**ADDENDUM #2**  
**To the Bid Documents for the**  
**Tennis Center HVAC Upgrade Project**

**Date: March 6, 2017**

### TENNIS CENTER HVAC UPGRADE

# MSK01

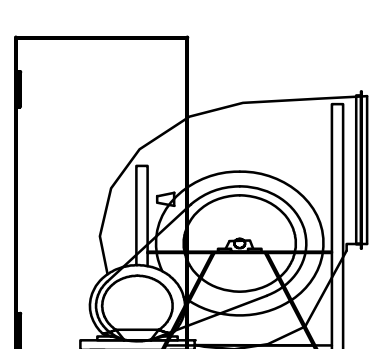
- a. Drawing M610 – MECHANICAL SCHEDULES AND DETAILS
  - i. Modify FAN SCHEDULE as indicated in attached sketch MSK01.

MARK	AIR FLOW RATE (CFM)	EXTERNAL S.P. (IN WG)	TYPE	MOTOR (HP)	ELECTRICAL (V/PH/HZ)	AREA SERVED	LOCATION	MODEL	NOTES
EF-1	3000	0.625	INLINE	1.0 ECM	208/1/60	AHU-1	134	SQND-EC	1, 2 <span style="border: 1px solid black; padding: 2px;">2</span>

1. MODEL BASED ON COOK. PROVIDE WITH PRESSURE CONTROL FOR ECM MOTORS.
2. PROVIDE WITH MOTORIZED BACKDRAFT DAMPER. 2
